South Texas Project Electric Generating Station 4000 Avenue F – Suite A Bay City, Texas 77414

February 10, 2010
U7-C-STP-NRC-100036

South Texas Project
Units 3 and 4
Docket Nos. 52-012 and 52-013
Response to Request for Additional Information

Attached are the responses to the NRC staff questions included in Request for Additional Information (RAI) letter numbers 299 and 302 related to Combined License Application (COLA) Part 2, Tier 2, Sections 3.7.1, 3.7.2 and 3.8.4.

Figure 03.07.01-20a

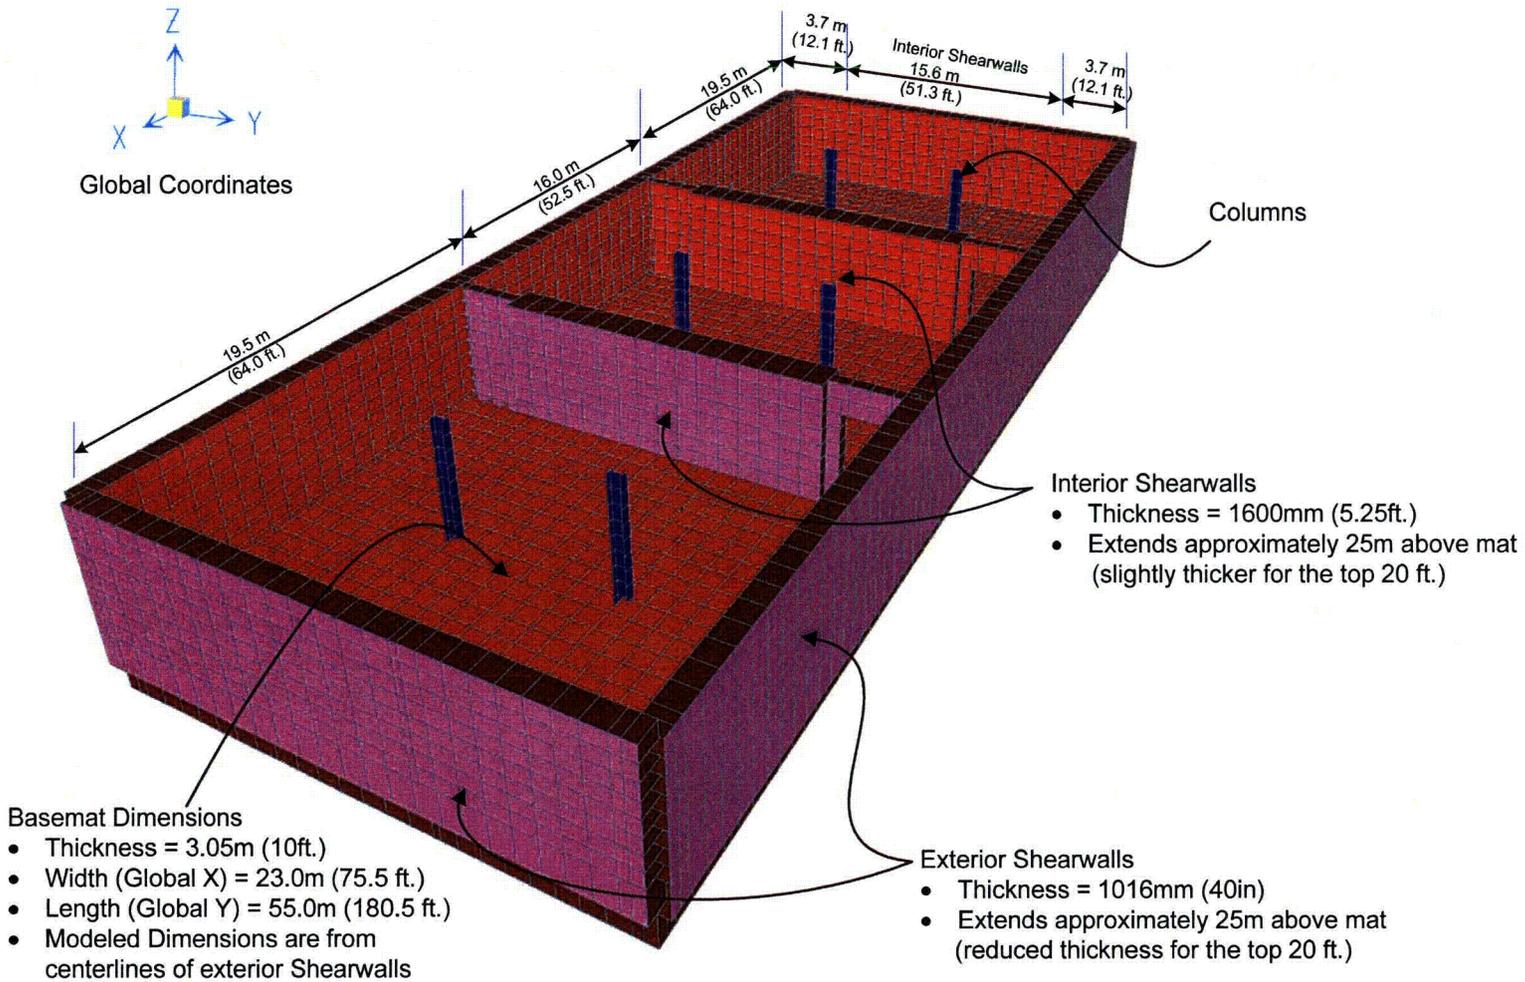
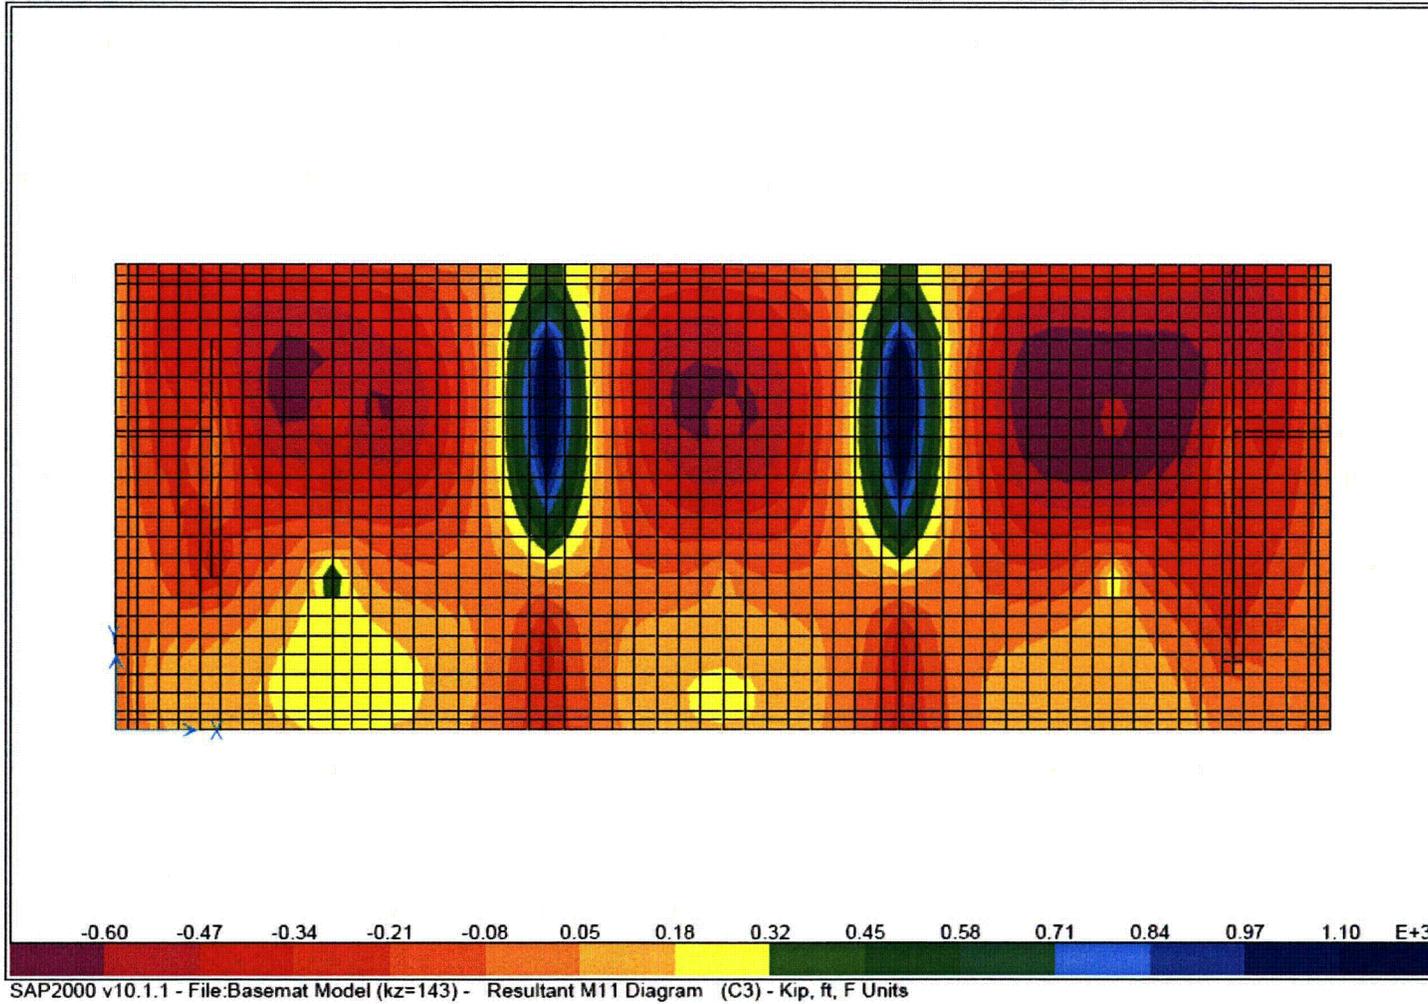
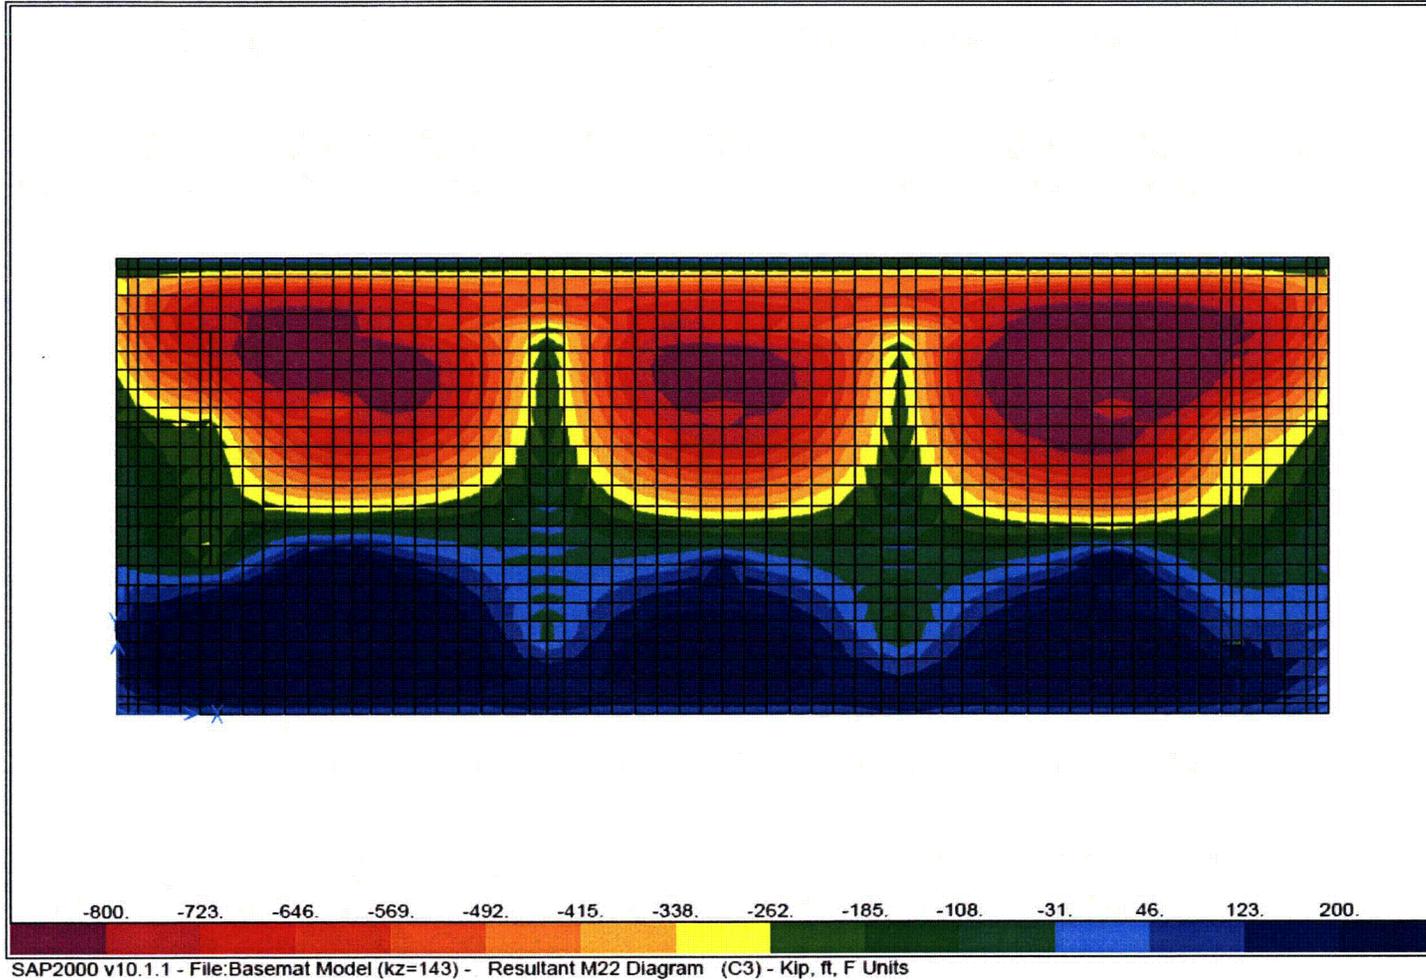
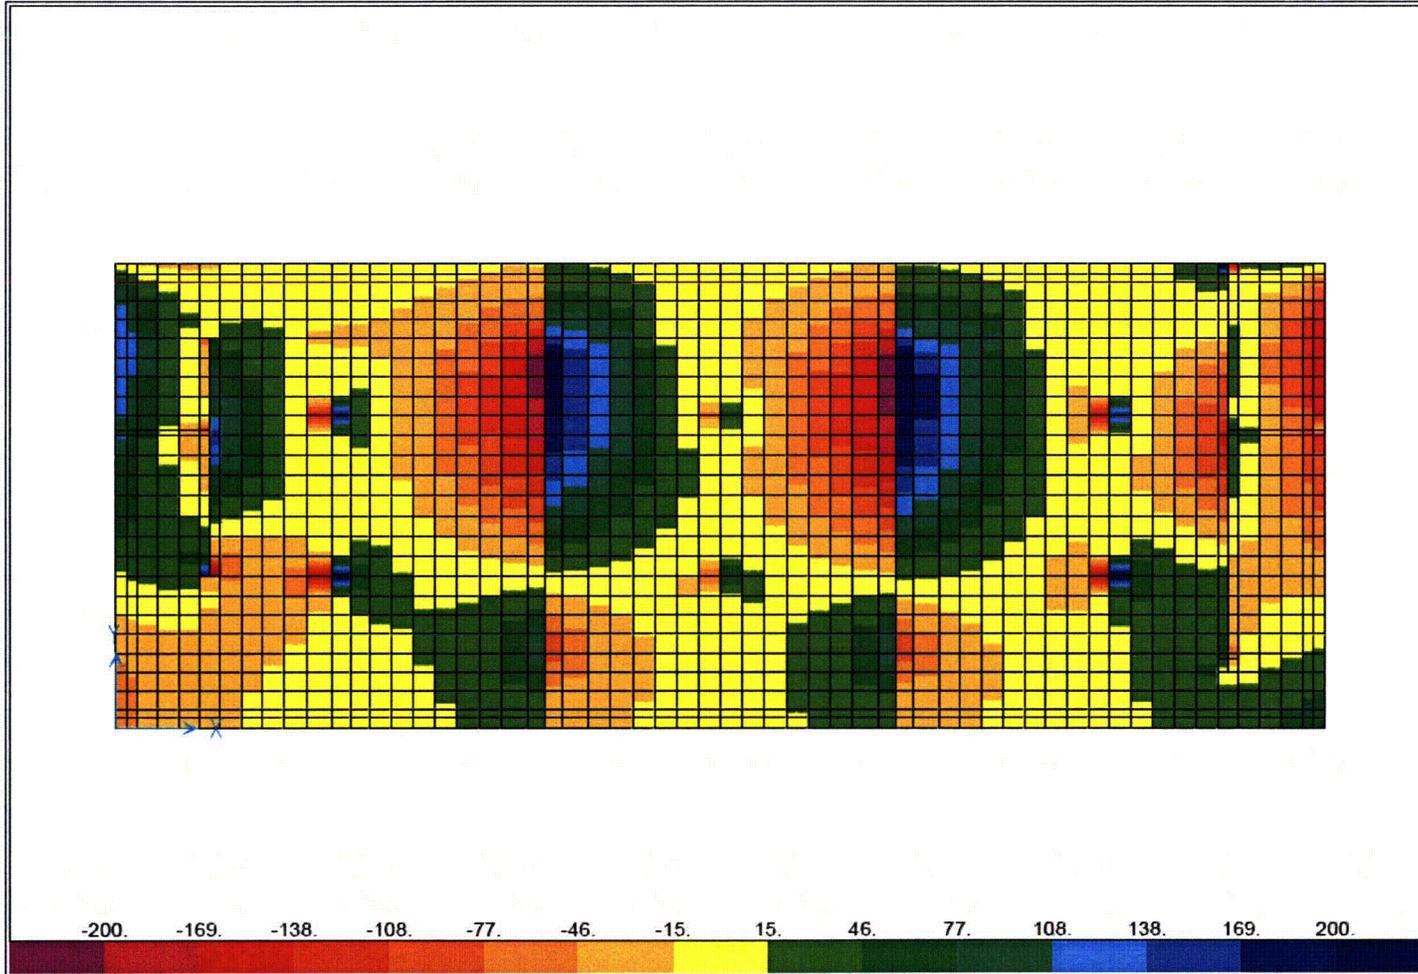
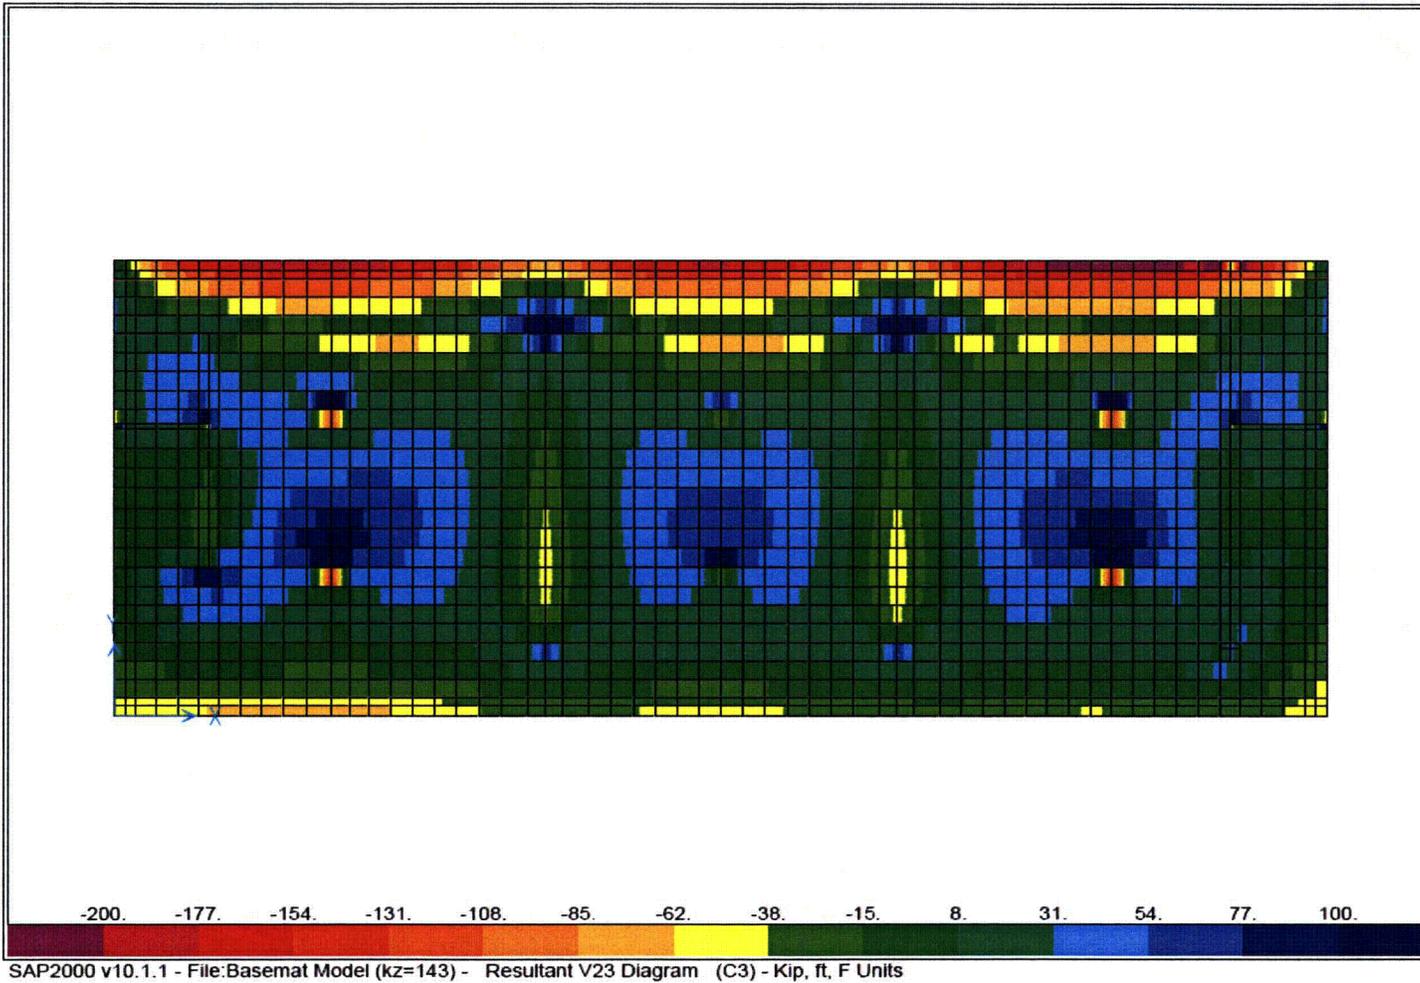
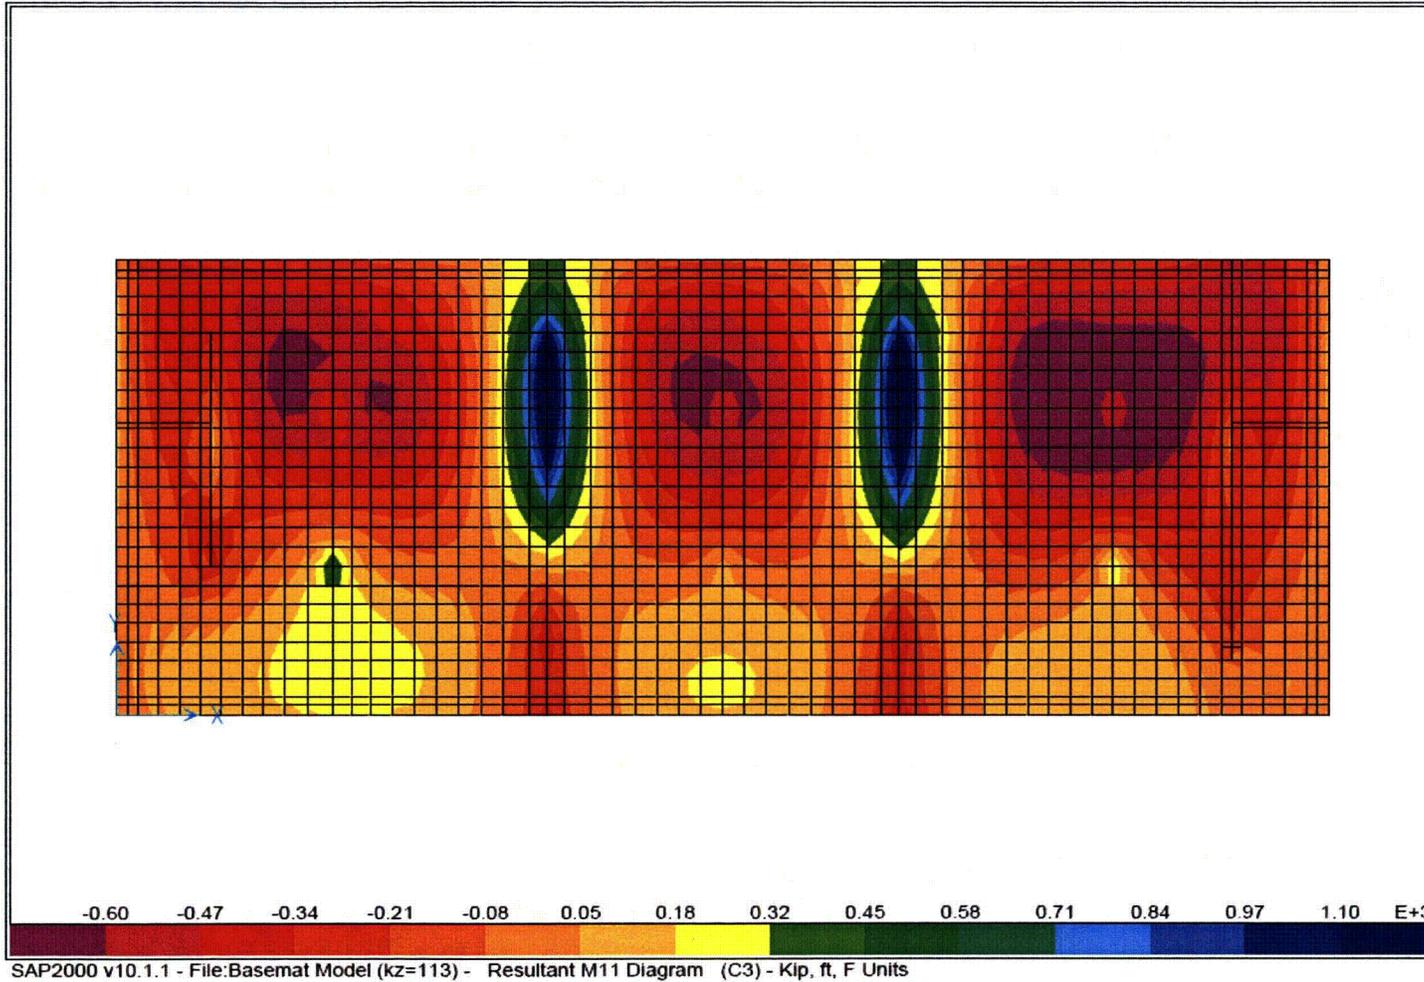
- (1) As shown in Table 2 in the response to RAI 03.07.01-7, a Poisson's ratio equal to 0.46 to 0.48 is used for calculating the soil spring constants that are used for the settlement evaluation and mat design. This high Poisson's ratio assumes that the vertical stresses transmitted to the saturated foundation soils are resisted by the incompressible pore water. Nonetheless, depending on the foundation soil permeability, the excess pore water pressures can dissipate quickly; thus, transferring the stresses to the soil grains. In light of the above, the applicant is requested to provide a comparison of the soil spring constant values, calculated using drained Poisson's ratio of foundation soils, with those of the ABWR DCD and justify any differences as to their effect on mat design forces.

- (2) In the response to RAI 03.07.01-7, the applicant stated that "*The spring constant values are provided only for the Reactor Building in the DCD. Therefore, a comparison of the spring constant values is provided only for the Reactor Building.*" This justification for not evaluating the effect of site-specific shear wave velocity on the Control Building (CB) foundation design is not acceptable. The applicant is requested to further justify that the design of the CB foundation at the STP site would still be bounded by the standard plant CB design.

As noted in part (2a) of this response, the calculated STP site-specific soil spring constants for the upper range and best estimate cases are the same as, or higher than, the best estimate soil spring constants used for the standard design. Higher soil spring constants at the STP site will result in mat design forces smaller than those used for the ABWR CB design. The lower range site-specific soil spring constants are lower than the best estimate DCD spring constants. However, even with lower range site-specific spring constants, the ABWR CB mat design is adequate for the STP site for the following reasons:

- Considering the size and geometry of the CB, arrangement of the exterior and interior shear walls, thickness of the shear walls (39 inch exterior walls and 63 inch interior walls), and the mat thickness (i.e. 118 inches), the CB mat design is quite rigid and not so sensitive to spring constant values. This can be seen from the parametric study results presented in Figures 03.07.01-20a through 03.07.01-20i provided with this response.

Figure 03.07.01-20a shows the layout of the mat and the shear walls of a structure with very similar arrangement to that of the DCD CB. The model used for this parametric study is a three dimensional finite element model. This model was analyzed twice for the total dead load of the structure along with significant seismic moment about the X-axis (along East-West), once with DCD best estimate spring constants and the second time with lower bound site-specific spring constants. Figures 03-07-01-20b through 03-07-01-20e present contour plots of the resulting out-of-plane moments and shears when using DCD spring constants. Figures 03-07-01-20f through 03-07-01-20i present contour plots of the resulting out-of-plane moments and shears when using lower range site-specific spring constants. Comparison of the resulting out-of-plane moments and shears from these two cases show that there is no significant change in mat design forces.
